# 802.3da Mixing Segment Specifications

## March 2024

Chris DiMinico  
PHY-SI LLC/ MC Communications/SenTekse  
[cdiminico@ieee.org](mailto:cdiminico@ieee.org)

Figure 168-17—Mixing segment and reference points

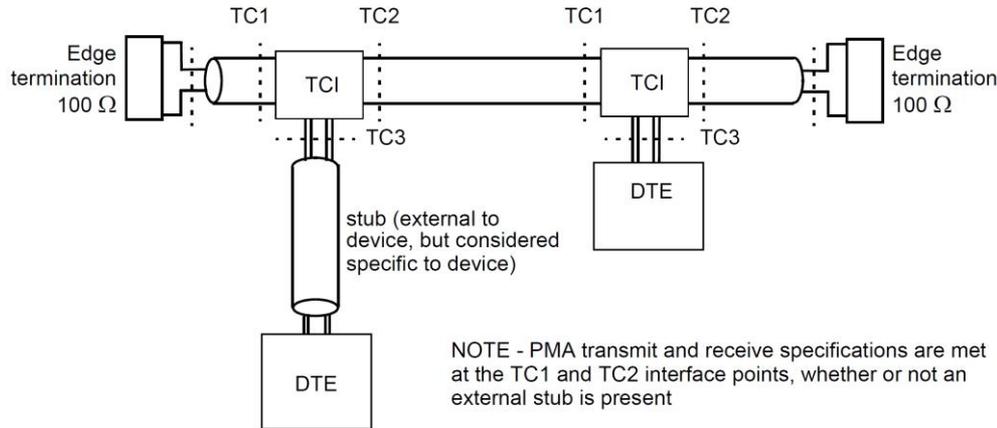
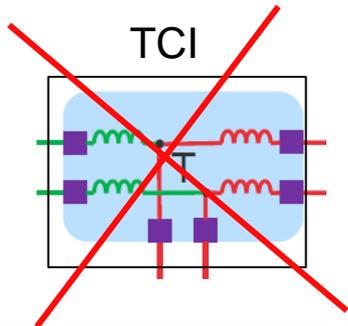
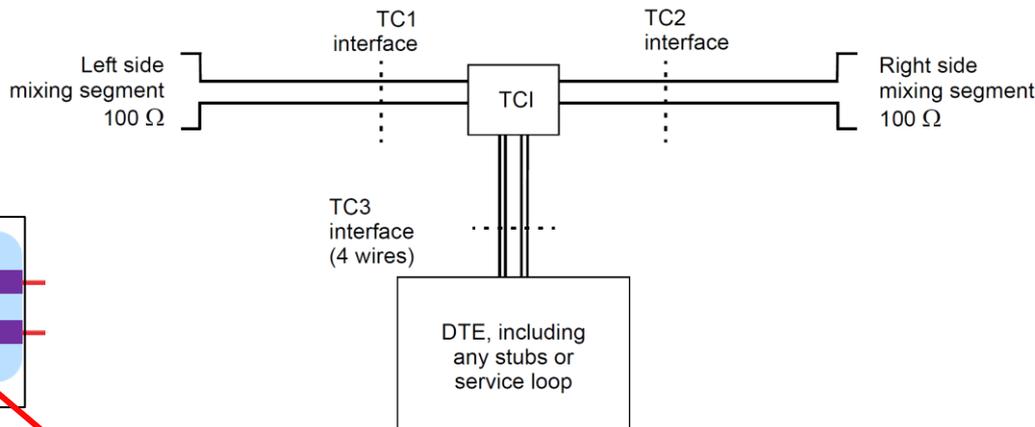
(1)>>Change text under 168.8 TCI specification line 34-36 and associated figure;

**From:** >>Each TCI has one interface facing each direction of the mixing segment (TC1 and TC2), and a four-wire interface facing the PMA (and any associated stub or service loop) (TC3) as shown in Figure 168–18.

*The coax cable interface (MDI) to the shared media is not three interfaces..... treat TCI similarly...*

**To:** Each TCI has one connection facing each direction of the mixing segment (TC1 and TC2), and a two-wire connection facing the PMA as shown in Figure 168-17 (slide 11). TC3 may not be accessible in an implemented system.

Figure 168–17—Mixing segment and reference points

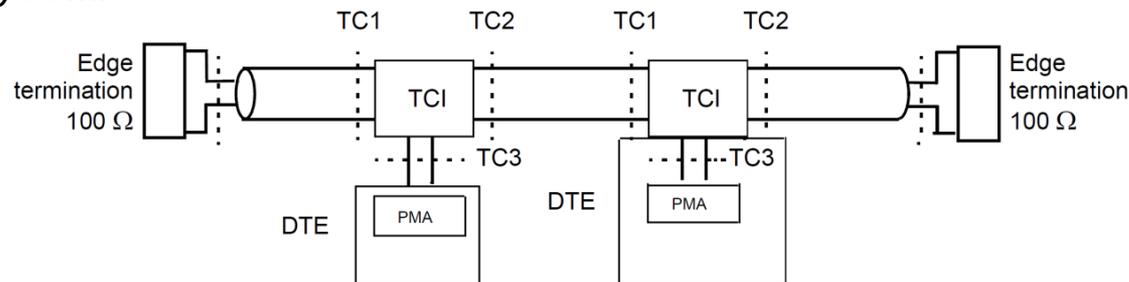
(2)>>Change text under 168.7 TCI specification line 8-11;

From: The mixing segment shall be a linear topology, with DTE attached at a TCI, where each TCI has two interfaces on the mixing segment, one interface facing in the direction of left edge termination of the mixing segment (TC1), and one facing in the direction of the right edge termination of the mixing segment (TC2), and a four-wire interface facing the PMA (and any associated stub or service loop) (TC3) (see Figure 168–18).

Changing to two-wire and removing service loops which can be implemented in trunk without calling it a TCI (four-wire)...

The mixing segment topology has the PMA or PMA load connected to a TCI, where each TCI has two connections on the mixing segment, one connection facing in the direction of left edge termination of the mixing segment (TC1), and one facing in the direction of the right edge termination of the mixing segment (TC2), and a two-wire connection facing the PMA (and any associated stub) (TC3). TC3 may not be accessible in an implemented system.

NOTE - PMA transmit and receive specifications are met at the TC1 and TC2 interface points.
